Addendum to Basement Impact Assessment

No. 39 Fitzjohn's Avenue

LBH4498bia Ver 1.3

April 2019

Camden 1920 Geological Map (Figure 2, CGHHS 2010)

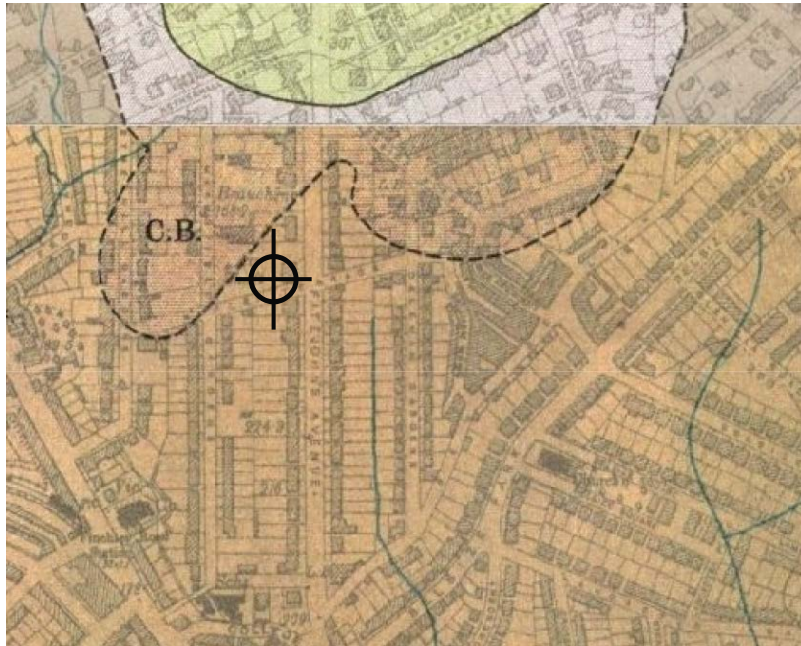
Question	Response	Justification
2. Is the site within 100m of a watercourse, well (used/disused) or potential spring line?	Yes	A tributary of the River Tyburn is located approximately 75m to the east of the site, as shown on the Camden 1920 Geological Map (CGHHS Fig 2). A map extract is provided in section 10.

London Clay is shown to underlie the site.

A tributary of the River Tyburn is shown 75m to the east of the site.
